CERTIFICATE OF APPROPRIATENESS

Property: 1806 Decatur, Tracts 7A & 8A, Block 44, Baker W R SSBB Subdivision. The property includes a historic 1,285 square foot, one-story wood frame single-family residence situated on a 3,000 square foot interior lot. Remodeled c. 2008. Carport added c. 1992

Proposal: Alteration – Openings

PROPOSED:

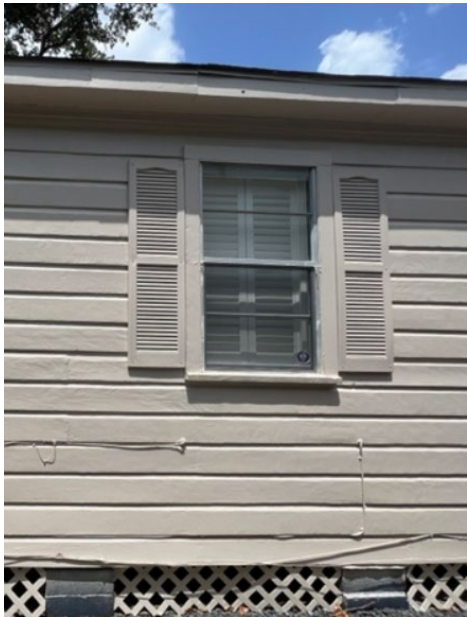
(SECOND DOOR TO BE INSTALLED ON LEFT)

New Door will go in the red block.

DOUBLE ENTRY SIMILAR TO 1804 DECATUR
